5 SUB2008-00264

HEADWATERS SUBDIVISION

DETAIL SITE PLAN

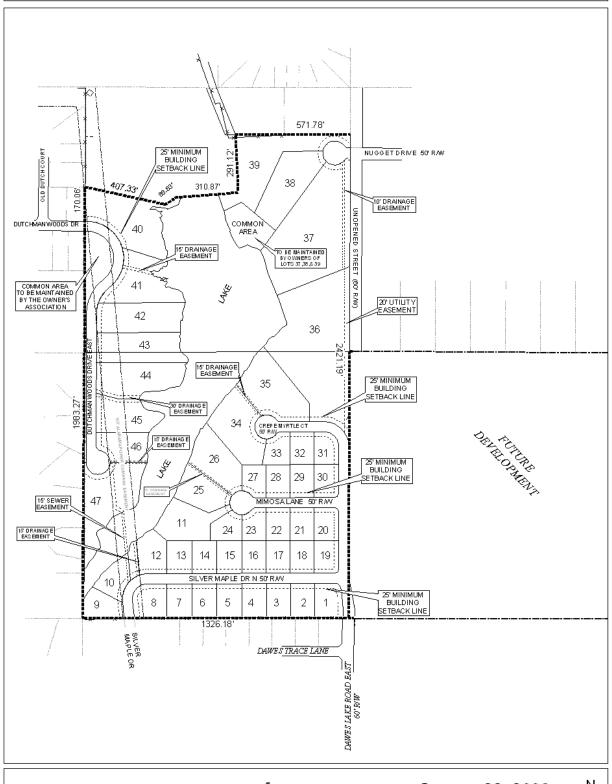
The proposed site would be accessed by Dawes Lake Road East, Dutchman Woods Drive, and Nugget Drive, all minor streets, which are illustrated on the preliminary plat with 60-foot right-of-way, in compliance with the Major Street Plan. The application proposes new streets, which must be constructed and dedicated to Mobile County Engineering standards prior to signing the Final Plat. It should be noted that the previous approval showed lots 37-39 as being accessed through a private cul-de-sac. The new submittal no longer shows the cul-de-sac as private.

Access management is also a concern. As Lots 1, 8, 19, 20, 30, 31, 36, & 37 are corner lots therefore, a note should be placed on the Final Plat limiting each lot to one curb cut each, with the size, design and location to be approved by County Engineering and conform to AASHTO standards.

As illustrated on the preliminary plat, the site contains a private lake, which indicates that the area may be environmentally sensitive; therefore, the approval of all applicable federal, state and local agencies would be required prior to the issuance of any permits or land disturbance activities.

Detention/retention or common areas are depicted on the preliminary plat; therefore, a note should be placed on the Final Plat stating maintenance of these areas will be the responsibility of the property owners.

- 1) All roads within the subdivision be constructed and dedicated to County standards;
- 2) Approval of all applicable federal, state and local agencies for wetlands prior to the issuance of any permits or land disturbance activities;

- 5) Placement of a note on the Final Plat limiting Lots 1, 8, 19, 20, 30, 31, 36, & 37 to one curb cut each, with the size, design and location to be approved by County Engineering and conform to AASHTO standards;

- 6) Labeling of all lots with the size in square feet, or placement of a table on the plat with the same information;
- 7) Depiction of the 25-foot minimum building setback lines from all street frontages;

9) Placement of a note on the plat stating that maintenance of the detention and common areas is the responsibility of the subdivision's property owners.
